CITY OF CODY  
PLANNING, ZONING AND ADJUSTMENT BOARD  
TUESDAY, OCTOBER 13, 2015  
CITY HALL COUNCIL CHAMBERS @ 12:00 NOON

**CITY OF CODY  
PLANNING, ZONING AND ADJUSTMENT BOARD  
STAFF REPORT**

<b>MEETING DATE:</b>	OCTOBER 13, 2015	<b>TYPE OF ACTION NEEDED</b>	
<b>AGENDA ITEM:</b>		P&Z BOARD APPROVAL:	X
<b>SUBJECT:</b>	SITE PLAN REVIEW: DINING PAVILION AT THE BUFFALO BILL CENTER OF THE WEST. FILE: SPR 2015-	RECOMMENDATION TO COUNCIL:	
<b>PREPARED BY:</b>	TODD STOWELL, CITY PLANNER	DISCUSSION ONLY:

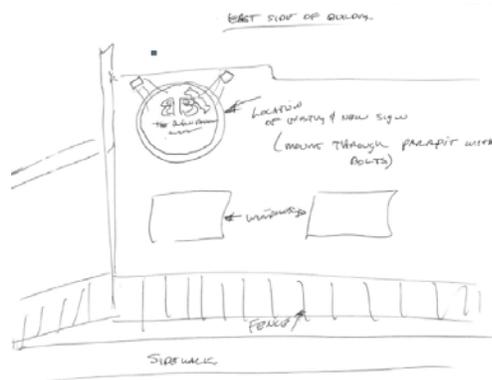
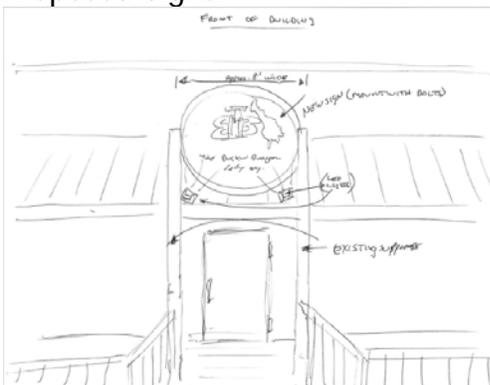
The sign for the front of the building is a freestanding sign. In the downtown sign district, the sign code allows the size and height (<25') of freestanding sign proposed. The wall signs on the side and rear of the building also comply with the size, number, and location requirements of the sign code (<1.5 sq. ft. of wall sign per foot of street frontage, no more than 2 wall signs per establishment, and mounted on wall).

The new signs will be on wood, metal, or similar backing material, and painted the colors of the logo. External LED lights will be used to illuminate the new signs. External illumination is permitted, provided the light fixture is directed and/or shielded to prevent glare impacts to passing drivers or pedestrians.

The purpose of the Downtown Architectural District is understood to be the promotion of architectural compatibility and preservation of historic features. The design and colors have a professional appearance and compliment the western character of the building.

Approve the signs for "The Buckin Burger" as presented. A building permit is required.

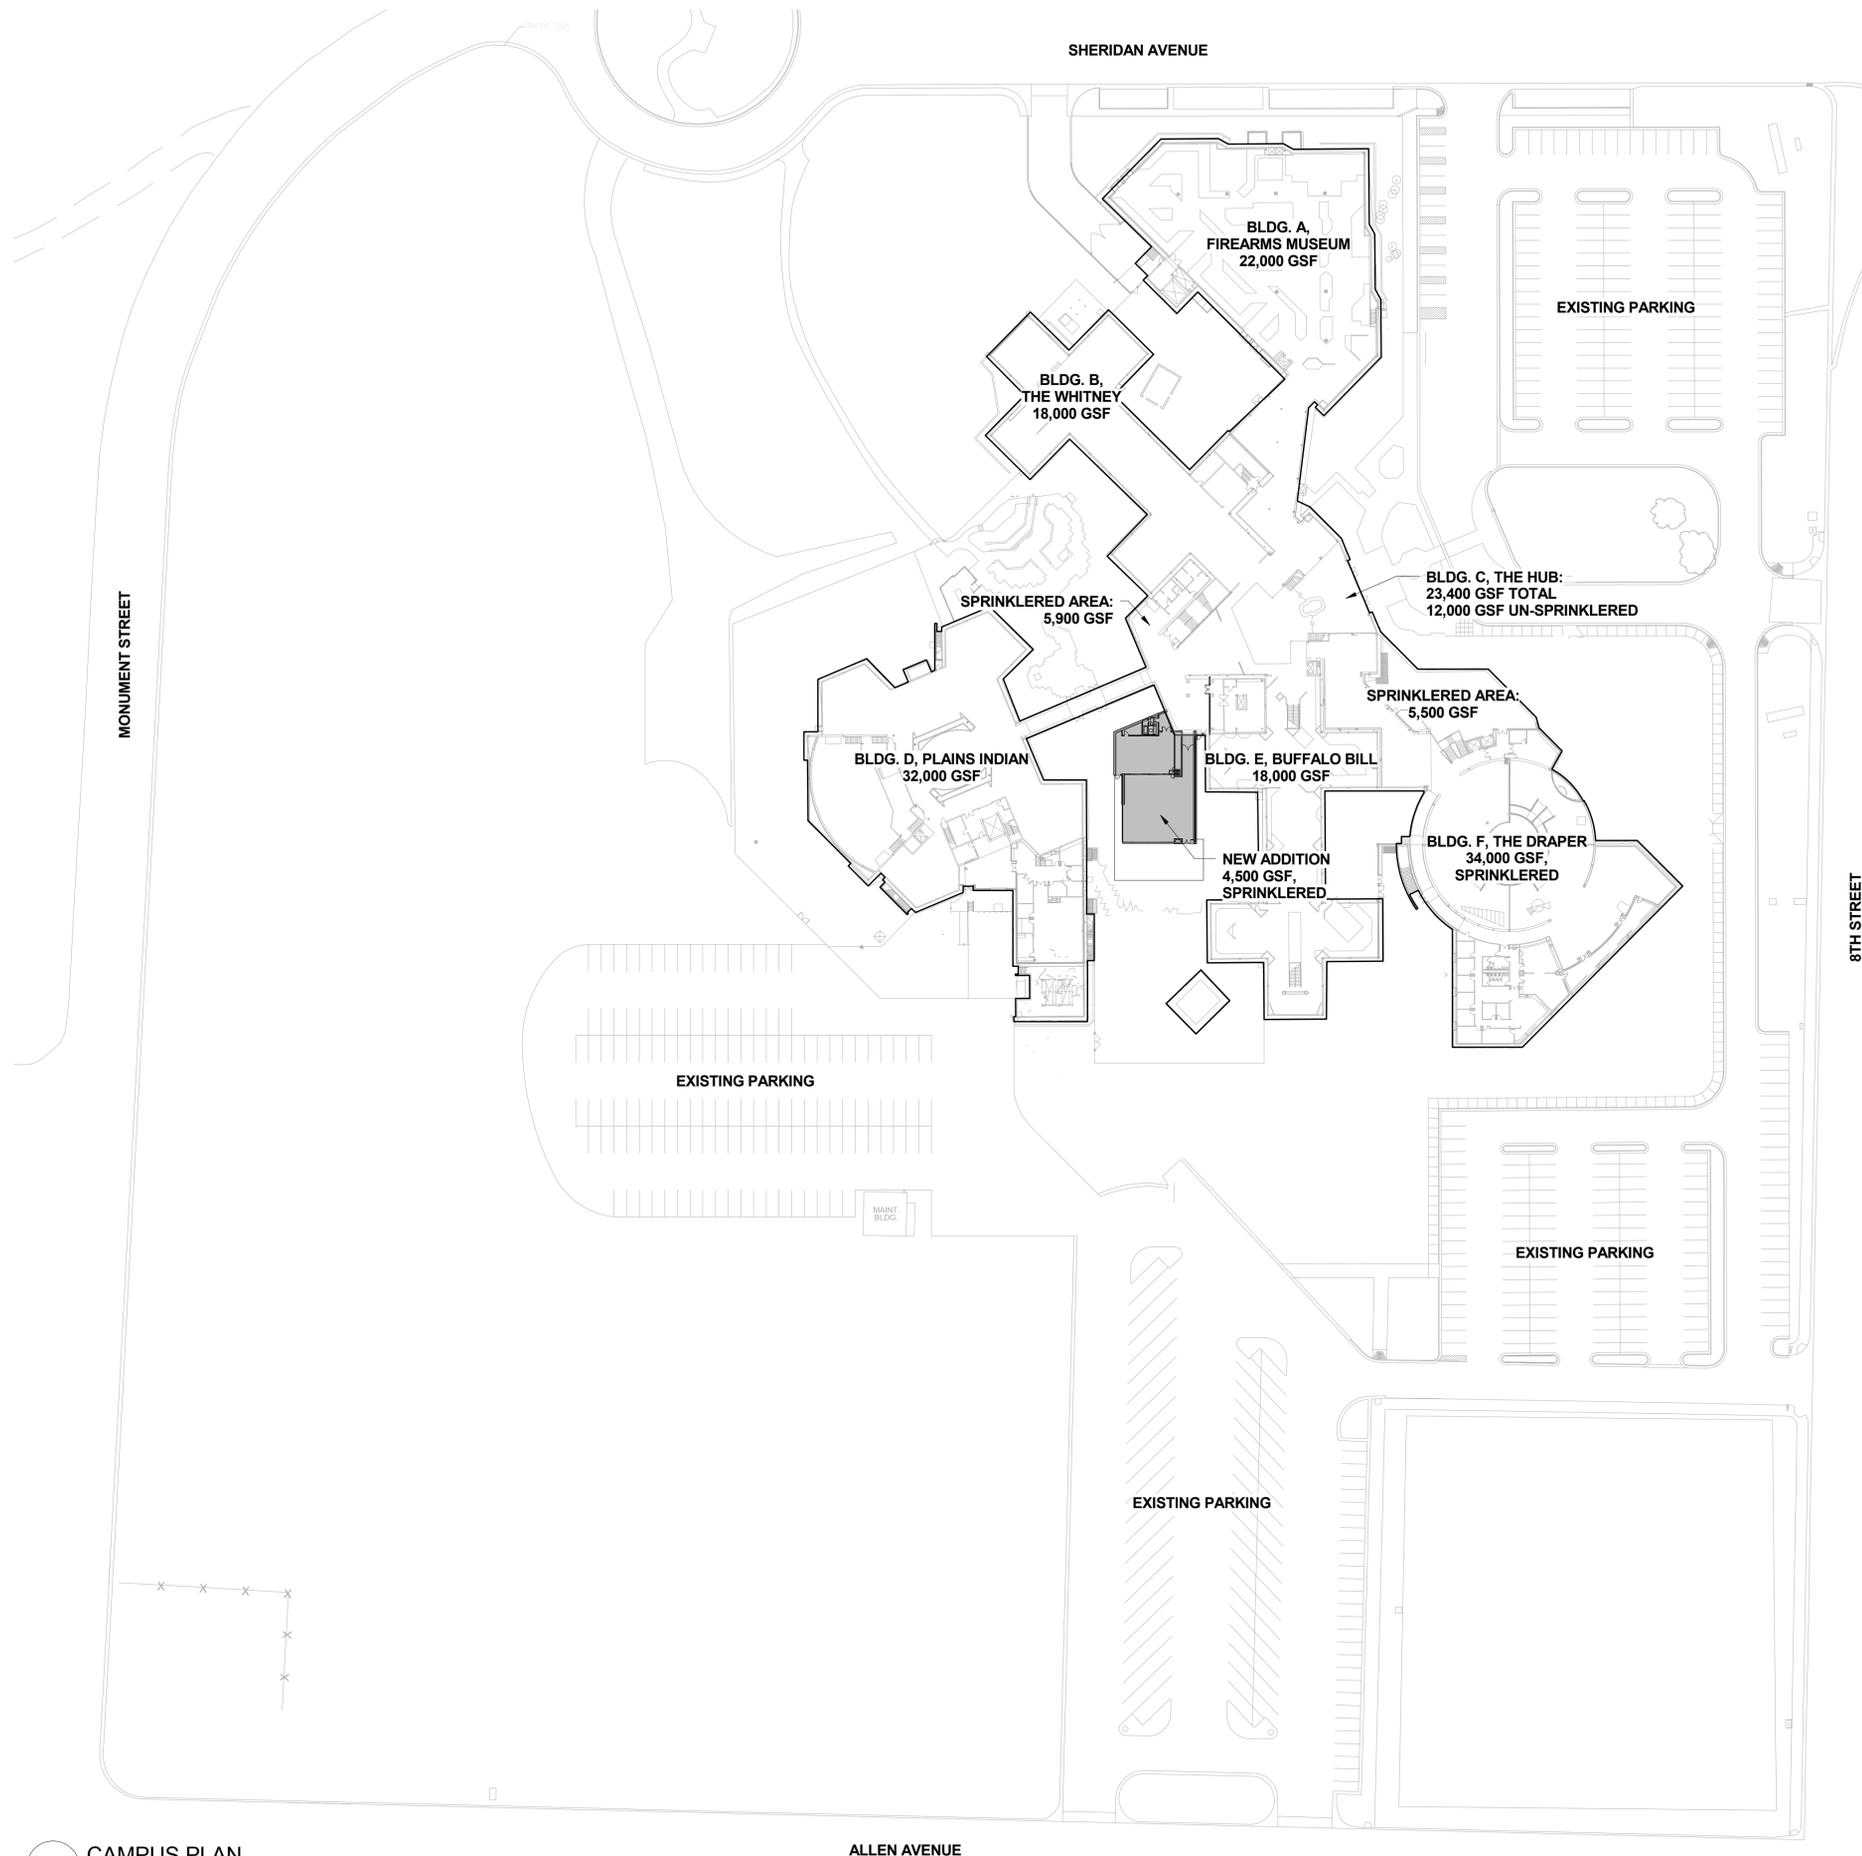
The proposed dining pavilion will be located in an existing garden area between the Buffalo Bill Museum and the Plains Indian Museum. It is our understanding that the

The quality architecture of the existing facility is continued with this project. As can be seen in the attached renderings and elevations, the south end with the fully glazed façade and gable style roof resembles the main entrance to the facility. The cantilevered roof is a great architectural feature. Other quality features include the stone veneer that will match the light tan sandstone of some of the existing walls, and the bronze colored standing-seam roof that will match the roofs of the other main buildings. Multiple other architectural features and designs are included to give the building the desired architectural result. The building meets the intent of the architectural review process.

The current project will remove a portion of an existing garden area and restore areas disturbed by construction around the building with grass. The museum actually has longer term plans to greatly enhance the remaining garden area, but due to a very short construction schedule for the building, the longer term plans are not yet prepared. Regardless, even with the new pavilion being constructed the museum will continue to have well over the minimum amount of landscaping required under the entry corridor overlay district in which it is located.

The cantilevered roof over the patio will have lighting incorporated. Detailed lighting plans are not included, but conceptually do not include any excessively bright or glaring light fixtures.

The storm water plan has been reviewed by the City engineer and found acceptable. The plan incorporates a series of inlets and underground pipes in the project area to collect and carry the storm water to an existing drywell, which has sufficient capacity to accommodate the additional storm water.

It is recommended that the Planning and Zoning Board approve the project subject to the following:

1. Prior to issuance of a certificate of occupancy, the drainage facilities must be inspected and certified by the applicant's engineer that they were completed according to approved plans.
2. The project must otherwise comply with the site plan and applicable building, fire, and electrical codes.

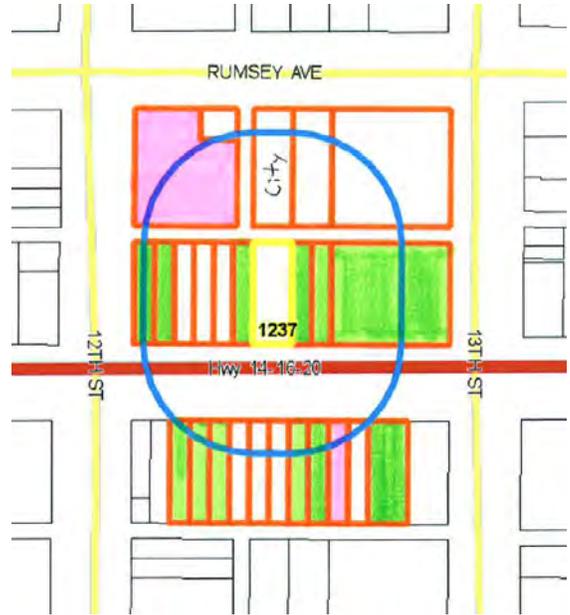
- 1) The property has 50 feet of street frontage, entitling it to 75 square feet of wall signage.
- 2) The stained glass sign was originally authorized as a canopy/awning sign. The concept and authorized location are represented by the following photo.

Canopy signs are allowed separately from wall signs in that each category of sign is calculated separately. The sign was not mounted where the application or approval indicated it would go. Staff did not do any enforcement on the sign as no complaints were received, and the sign did not cause the amount of wall signage to exceed the amount allowed.

- 3) The unauthorized location of the stained glass sign does not fully comply with the sign code because it extends above the wall/roof line.
- 4) As a wall sign, the stained glass sign is approximately 40 square feet in size.
- 5) The downtown sign district only allows the following number of wall signs: “1 per face of store front, 1 per street frontage, not to exceed 2 signs per establishment max.” (Admittedly staff missed this requirement previously.)
- 6) The six new yellow signs were installed without the knowledge or permission of the city staff.

8) The sign code indicates that internally illuminated signs may be allowed, provided the light source shall not be visible from the exterior of the sign. The yellow signs have small bare incandescent bulbs (C9 style or similar) mounted within the signs that are clearly visible.

Staff Comment: At least one deviation request could be eliminated by relocating the stained glass sign to the canopy as originally indicated. To correct the exposed light issue, plastic could be added to the front of each letter, but whether or not that is feasible has not been explored.

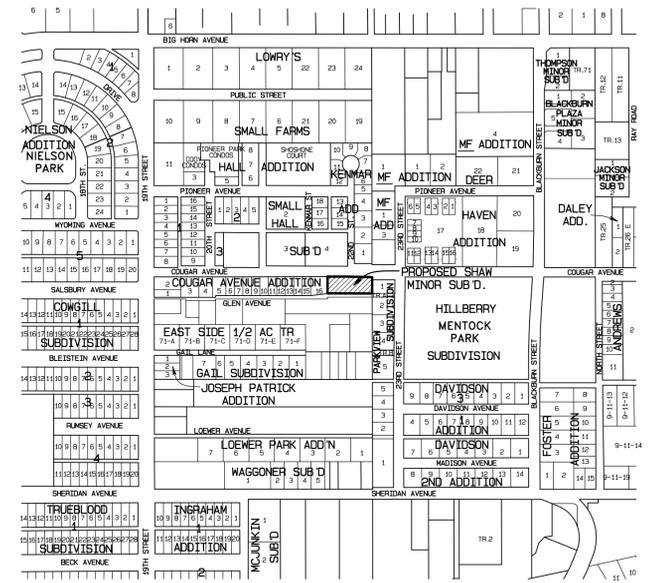
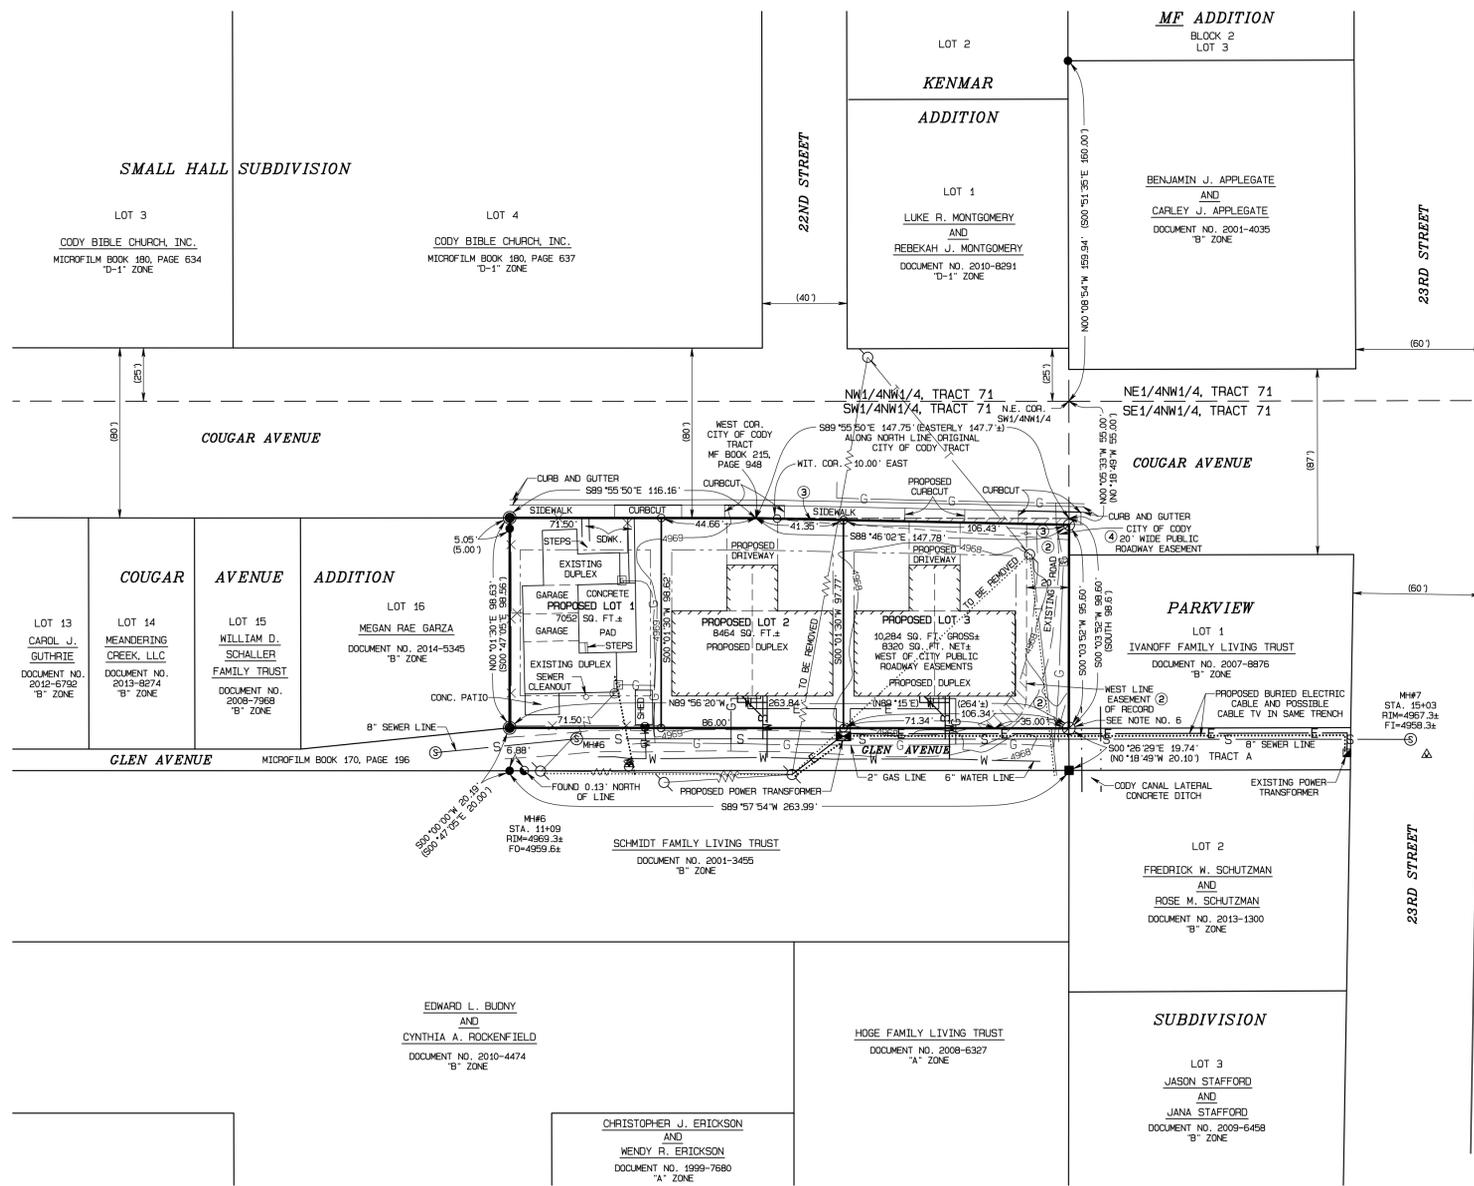
Comment: The 20-foot wide utility and public access easement on the east side of the property functions as the alley from Cougar Avenue to Glen Avenue. Over time the physical alley has crept outside of the easement. The alley will physically need to be taken back into the easement as part of this development, which would be the responsibility of the developer. If this alley is to remain, technically staff believes it should be dedicated as an alley (owned by the City) rather than remain just a utility and public access easement, as this is the requirement referenced.

Comment: Applicable lot size, lot coverage, lot frontage, and setback requirements are met, with the exception of a storage shed on Lot 1 that is located about two feet from the alley line and four feet from the proposed side lot line. The shed will need to be moved to be five feet from each property line to meet code.

Comment: A sewer main is located in Glen Avenue along the south side of the subdivision. Sewer service lines are needed for Lots 2 and 3. Lot 1 has an existing

Comment: A water main is located in Glen Avenue. Water taps are needed for Lots 2 and 3. Lot 1 has an existing water service. The preliminary plat shows the intended water services. Coordinate water taps and connection fees with public works.

Power. Electrical service will need to be extended from 23<sup>rd</sup> Street to the common corner of Lots 2 and 3, and a new transformer set, as shown on the preliminary plat. The electrical estimate for the city portion of that work will need to be paid before the final plat is recorded and the electrical system must be completed before building permits can be issued. The overhead power line across Lot 2 would be removed at that time as well.

Recommend that the City Council approve the Preliminary Plat and Final Plat for the Shaw Minor Subdivision subject to the following conditions:

1. Dedicate the existing utility and public access easement along the east side of the property as a right-of-way (alley); and, physically relocate Glen Avenue to be within the dedicated alley. The final plat certificate and map must be updated to include the right-of-way dedication.
2. Note that the applicable building setback from the east side of Lot 3 is five feet.
3. Relocate the storage shed to meet setback requirements, prior to the mayor signing the final plat.
4. Otherwise complete the improvements required by the subdivision ordinance and as noted on the preliminary plat. The electrical estimate and the utility connection fees, including a water line reimbursement fee, will be collected with the final plat.
5. Provide a final plat mylar for applicable signatures and recording.
